Addendum # 1

Bid Opportunity: 25-7706-RFT - Glenview Park Secondary School Elevator and Science Laboratory Renovation

RE: Glenview Park Secondary School
Elevator & Science Laboratory Renovation
Cambridge, ON

ADDENDUM 01

SCALE	DRAWING NUMBER
As indicated	
SHEET SIZE	
24X36	
PROJECT NUMBER	M3.3
24162

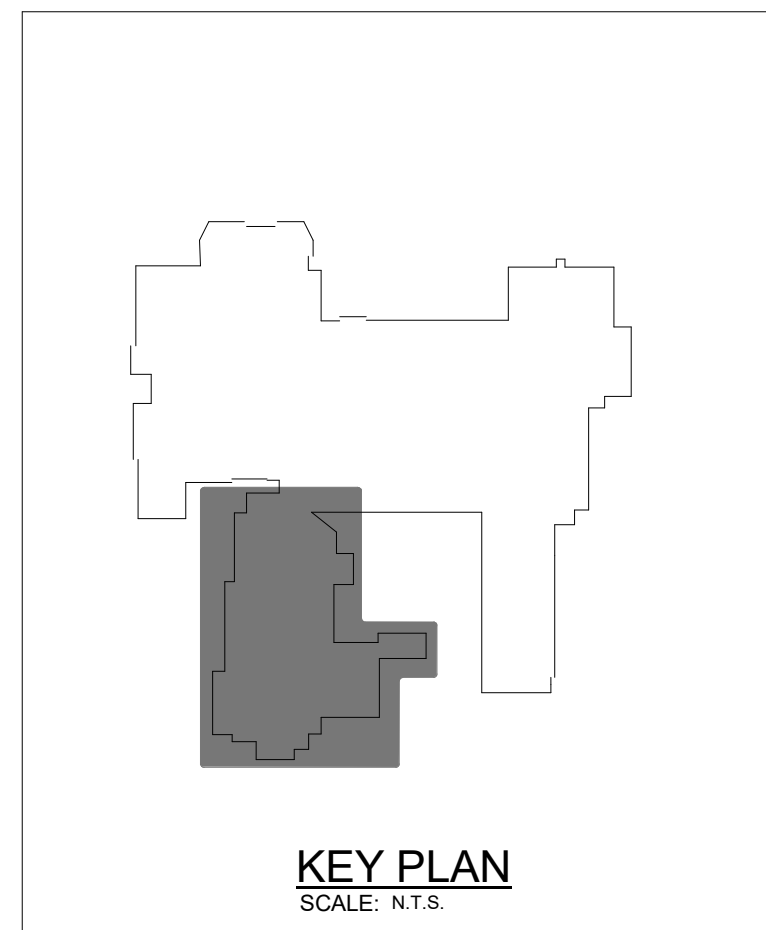
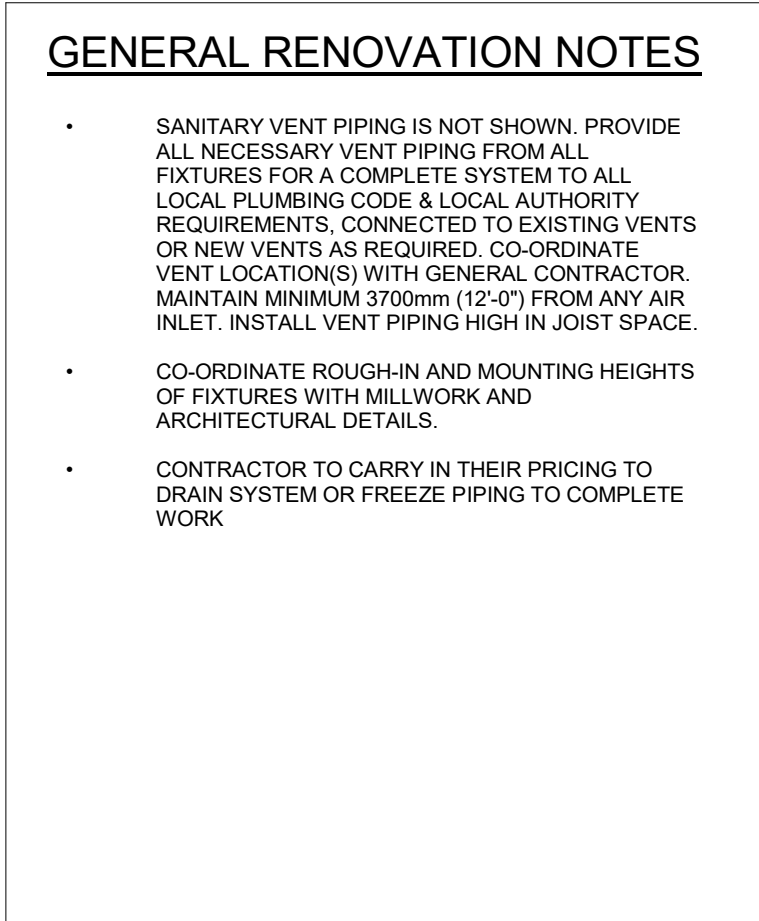
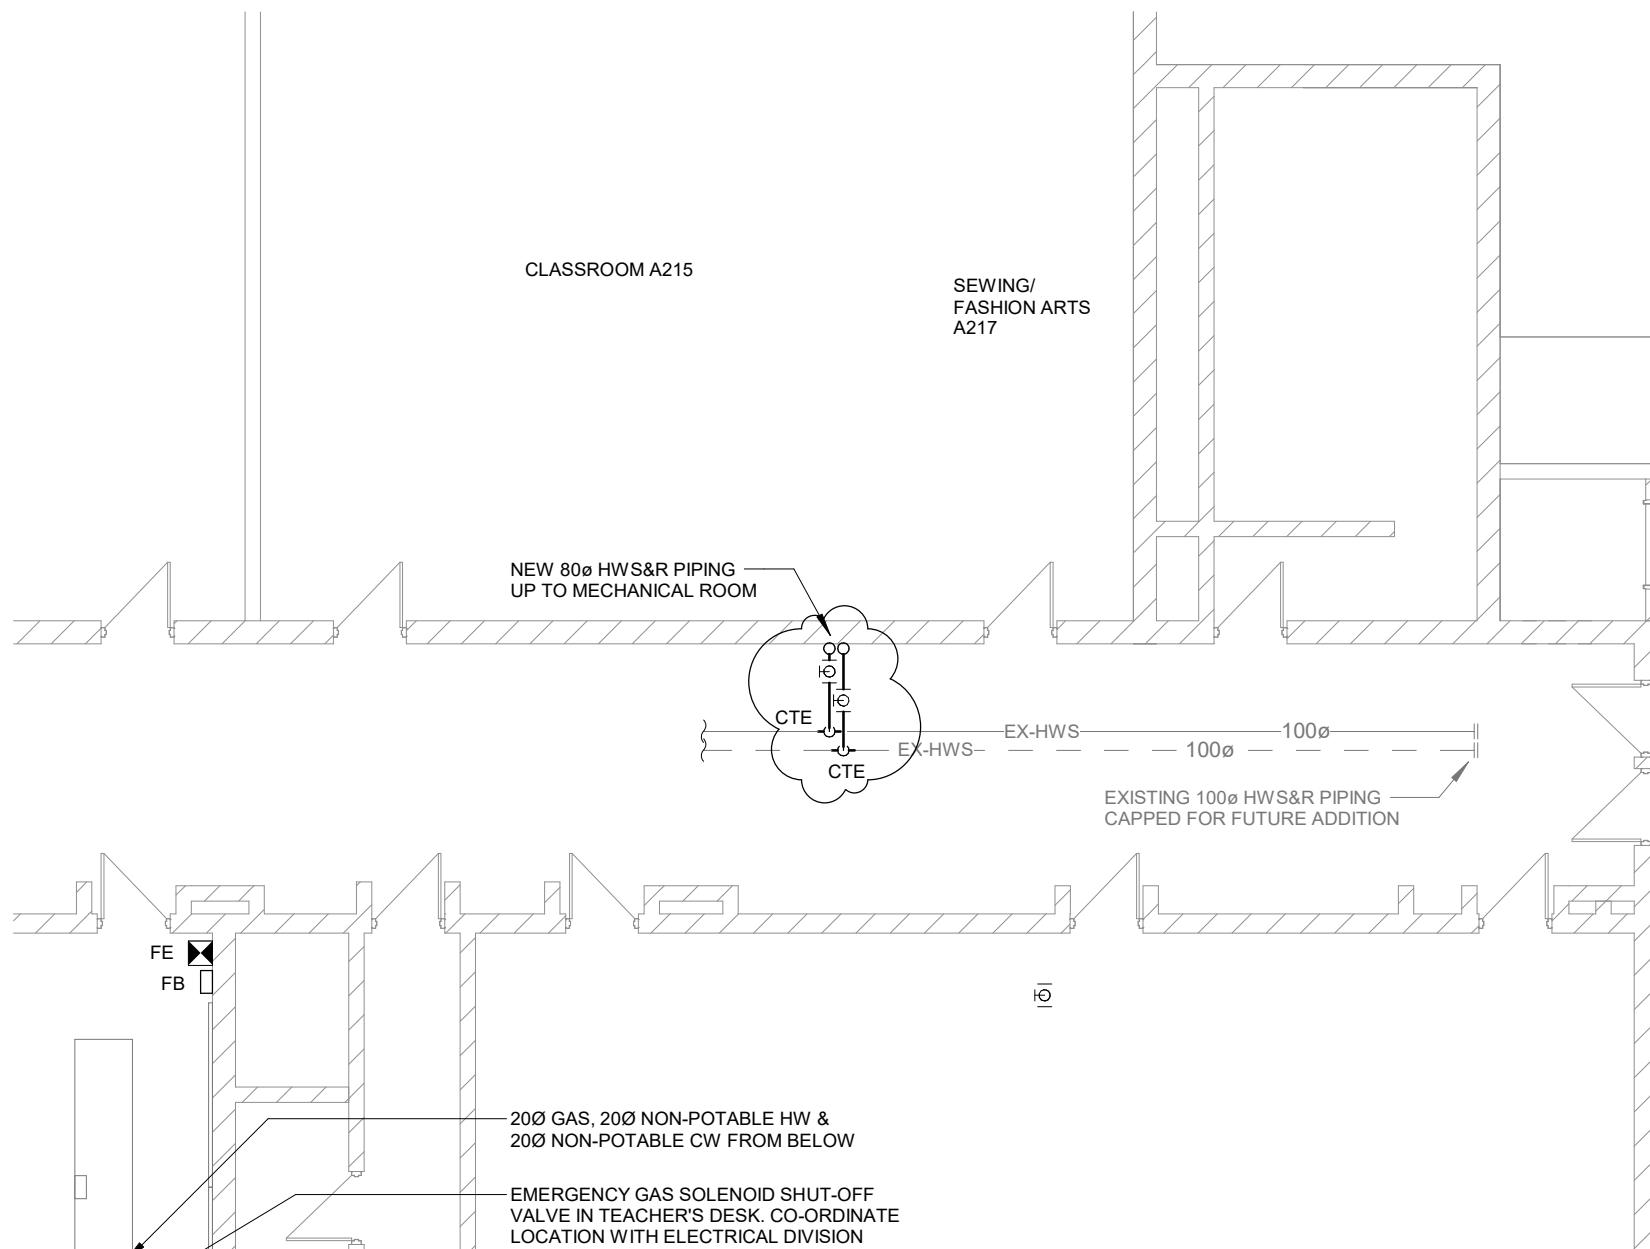
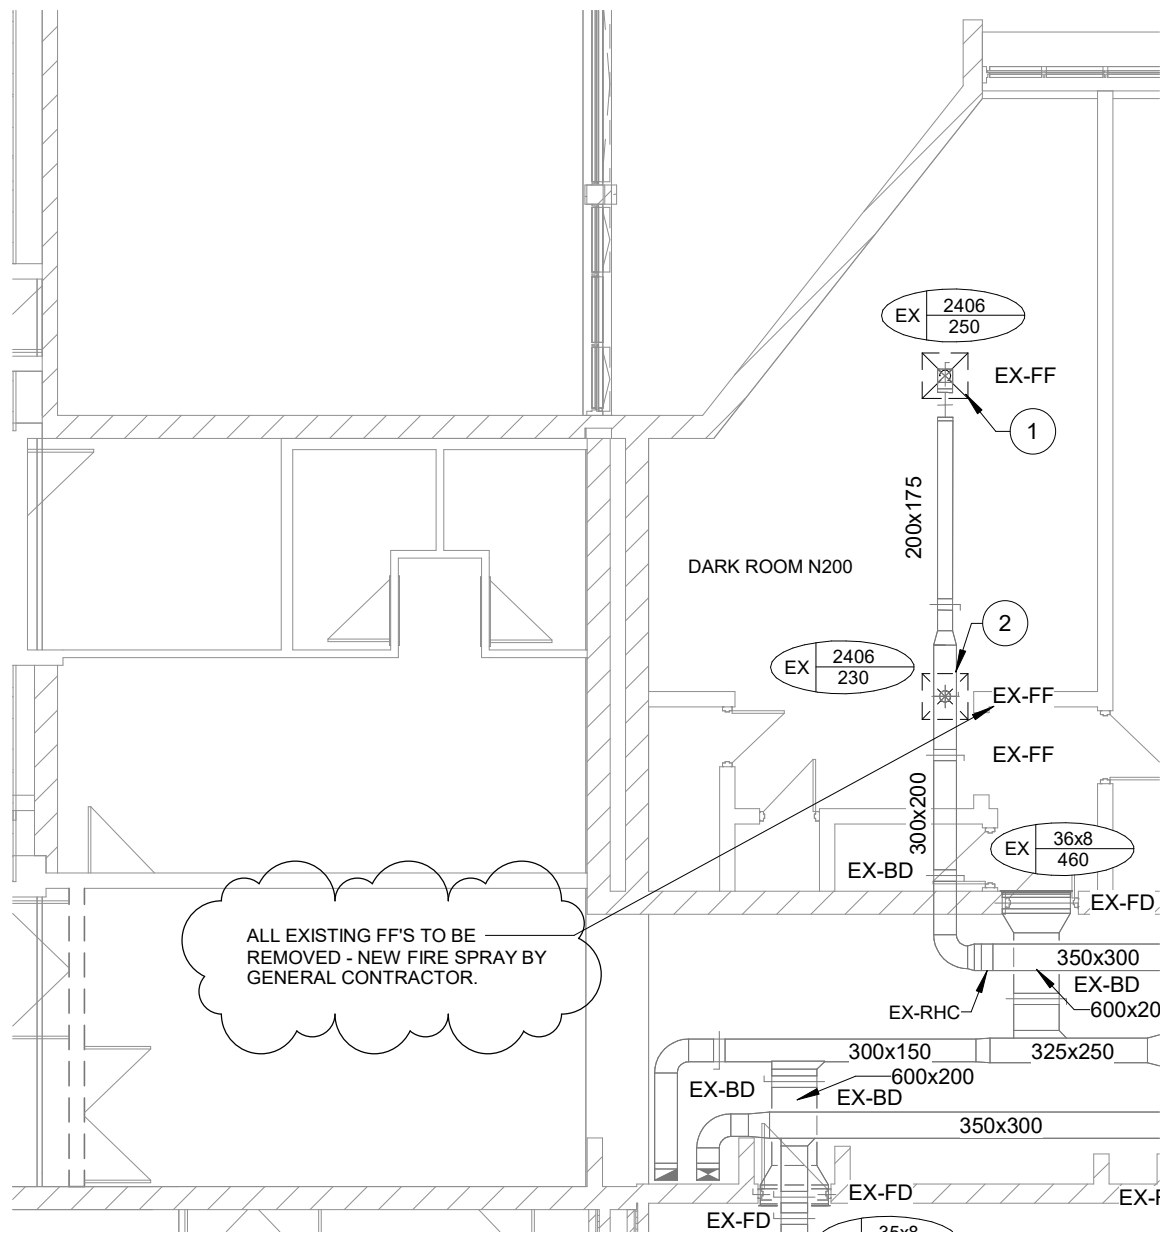
- 6.0 Reference Attached Reissued Drawing M3.3
 .1 Revise piping as per attached reissued drawing M3.3.

M6.1

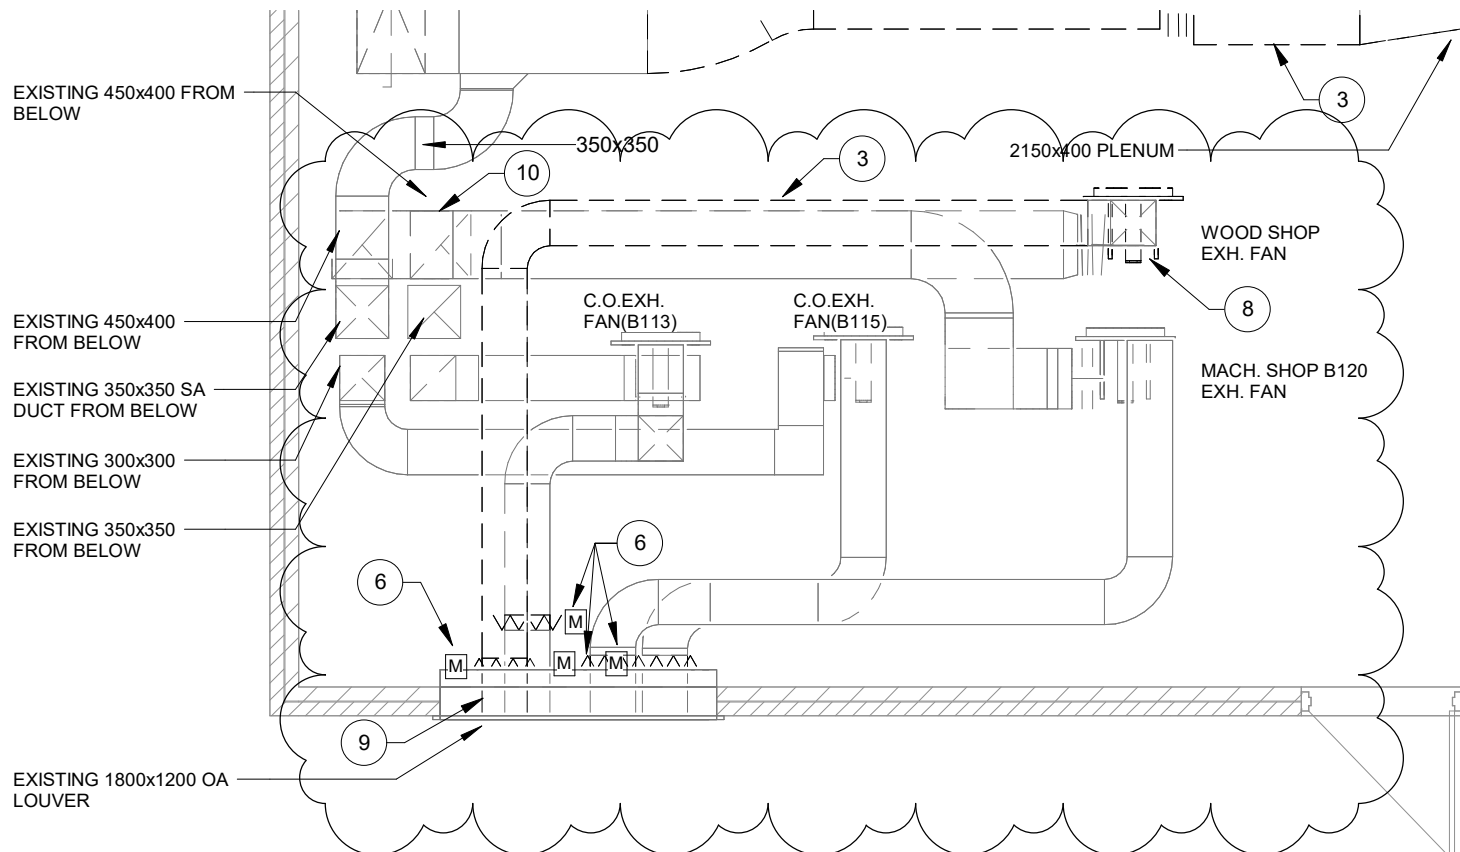
- 9.0 Reference Attached Reissued Drawing M6.1
 .1 In 'Mechanical Room – Piping & Drainage Demolition (Phase 2)', remove existing supply unit AH-5 control panel completely as per attached reissued drawing M6.1.
 .2 In 'Mechanical Room – Piping & Drainage Renovation (Phase 2)', revise HVAC-5 heating coil piping as per attached reissued drawing M6.1.
 .3 Revise 'Specific Demolition Notes' and 'Specific Renovation Notes' as per attached reissued drawing M6.1.

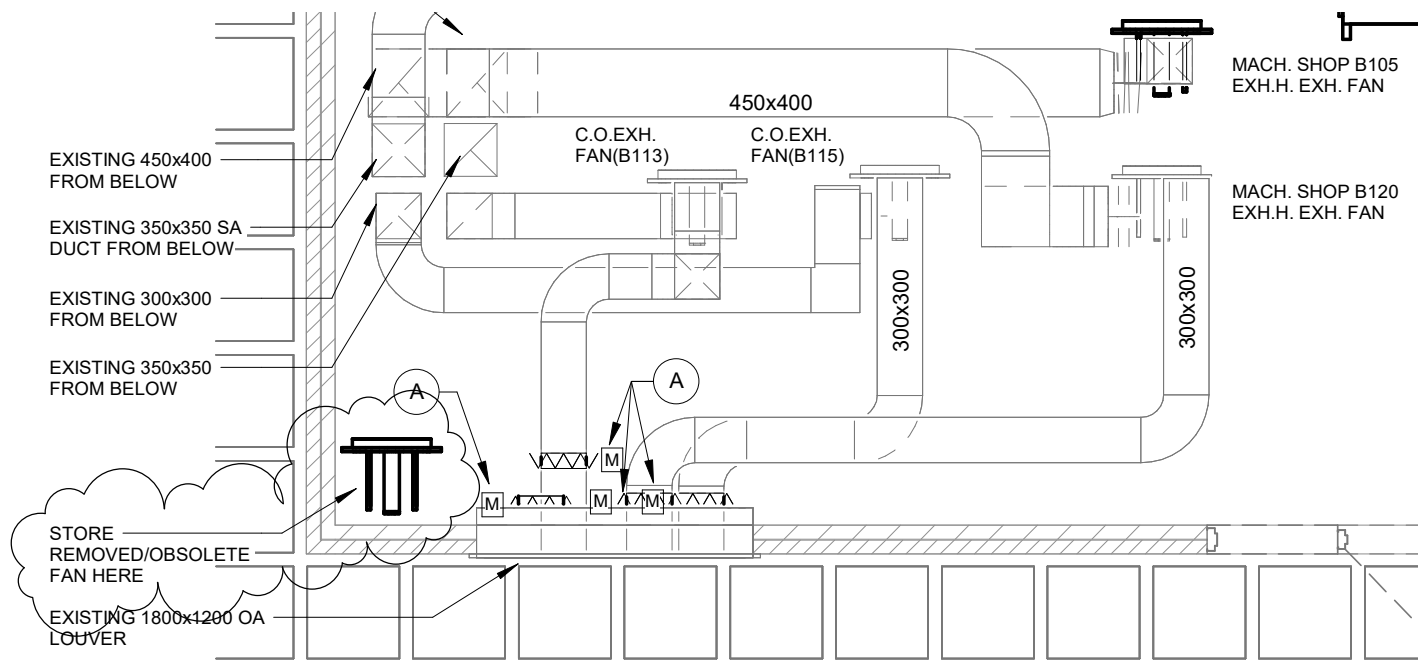
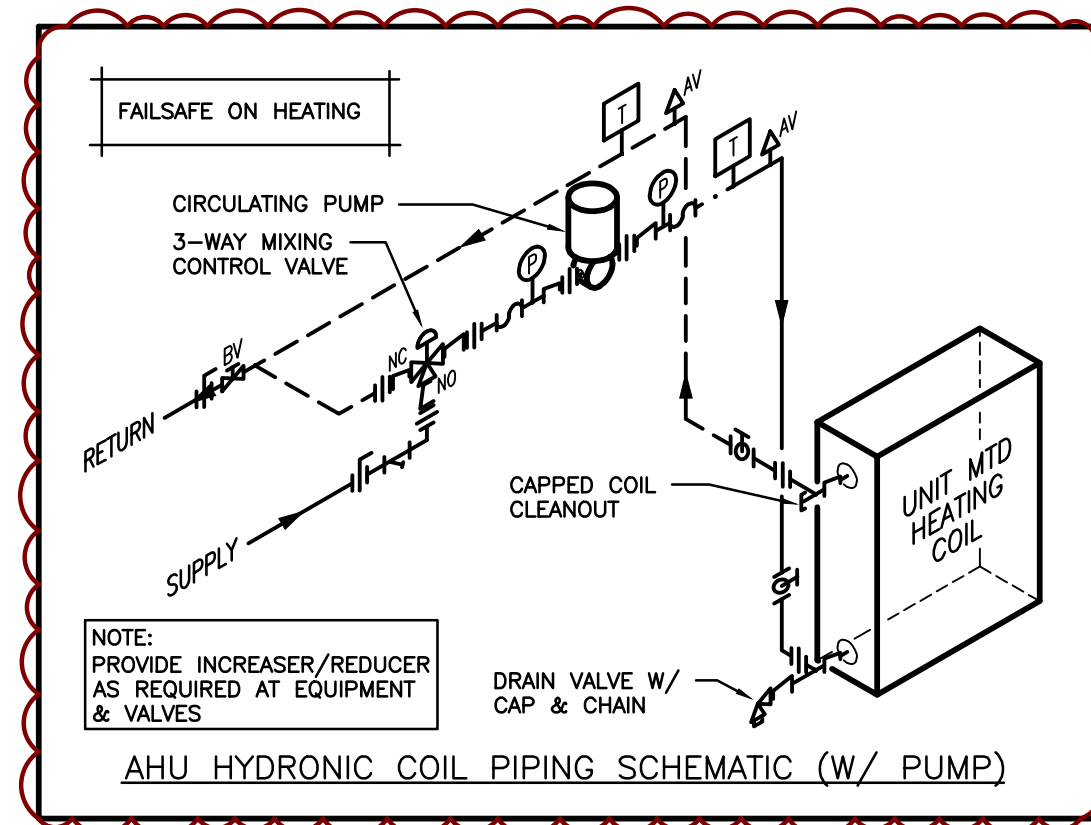
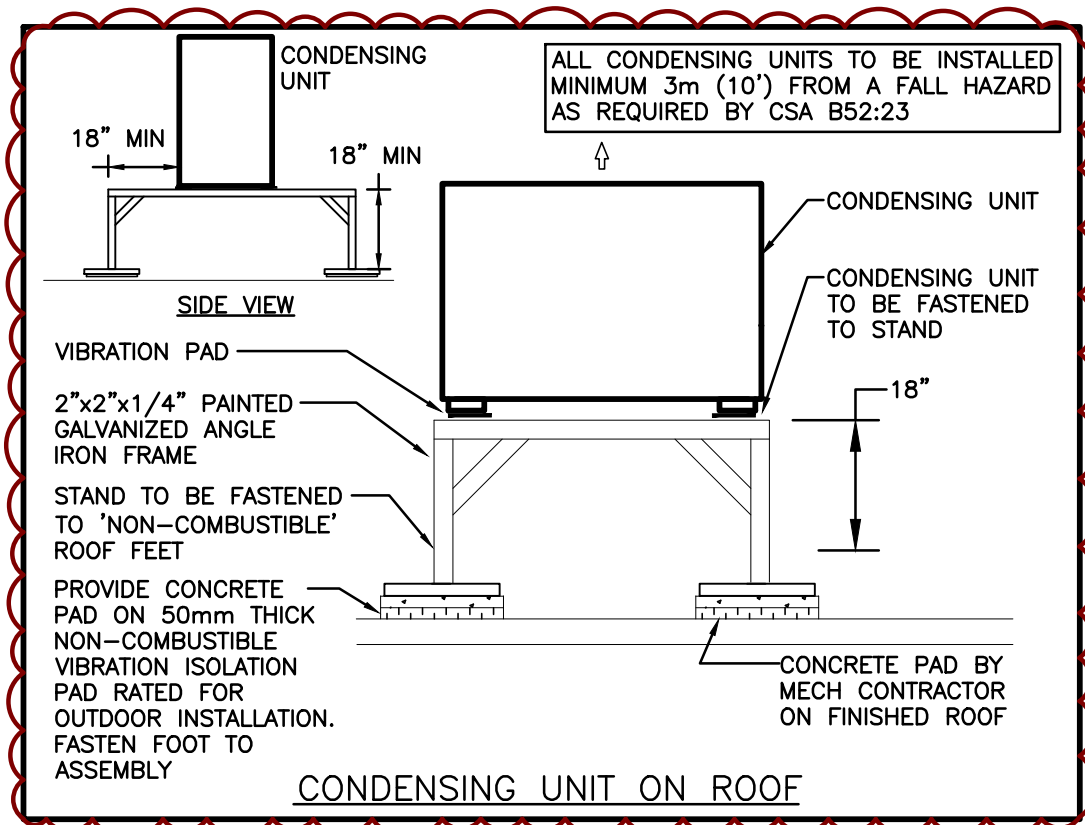
- 10.0 Reference Drawing M6.2 and Attached Sketches ADD01-M07 and ADD01-M08
 .1 In 'Mechanical Room – Ventilation Demolition (Phase 2)', remove existing obsolete exhaust fan and store on site as per attached sketch ADD01-M07 and ADD01-M08.
 .2 Revise 'Specific Demolition Notes' as per attached sketch ADD01-M07.

8. EXISTING OBSOLETE EXHAUST FAN TO BE REMOVED COMPLETE AND STORED ON SITE IN MECH ROOM FOR FUTURE USE BY OWNER.
9. EXISTING DUCTWORK TO BE CUT AT LOUVER/PLENUM AND REMOVED BEYOND COMPLETE.
10. EXISTING DUCT TO BE REMOVED COMPLETE. CAP IN CEILING SPACE BELOW. COORDINATE FLOOR OPENING INFILL WITH GENERAL CONTRACTOR.

DRAWING TITLE
**LEVEL 2 - SCIENCE
WING - ELECTRICAL
RENOVATION PLAN**

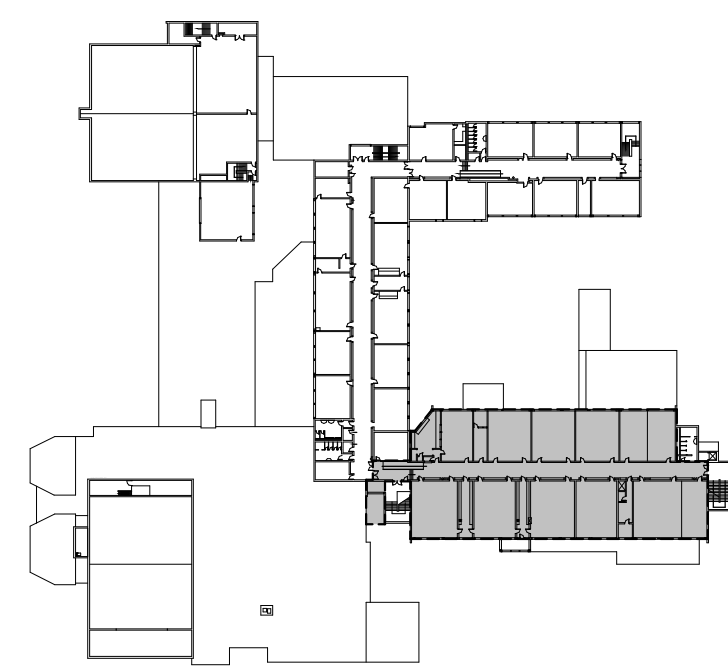
- .1 Fire smoke damper added near Room A205.

- 15 PROVIDE 120V POWER AND FIRE ALARM CONNECTIONS TO FIRE/SMOKE DAMPER C/W INTEGRAL SMOKE DETECTOR. REFER TO FIRE ALARM SPECIFICATIONS AND TO RISER DIAGRAM FOR FURTHER DETAILS. COORDINATE EXACT LOCATION WITH MECHANICAL CONTRACTOR PRIOR TO ROUGH-IN.

SCALE 1 : 50	DRAWING NUMBER E304
SHEET SIZE 24X36	
PROJECT NUMBER 24162

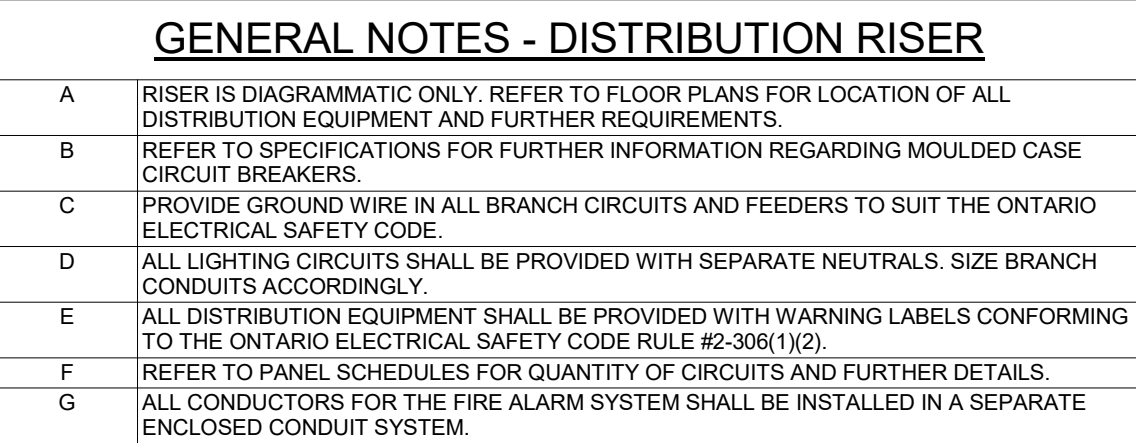
- .1 Existing exhaust fan unit to be demolished. Refer to detail A/304.
- .2 HVAC-5 Circulation Pump (P-10) added. Provide 208V 3PH power and starter for equipment as shown. Refer to detail B/304.

INDICATES EXISTING FAN UNIT TO BE REMOVED
COMPLETE BY MECHANICAL CONTRACTOR. ELECTRICAL
CONTRACTOR SHALL REMOVE EXISTING CONDUIT AND
WIRING BACK TO SOURCE PANEL AND MAKE SAFE. MARK
BREAKER AS SPARE.
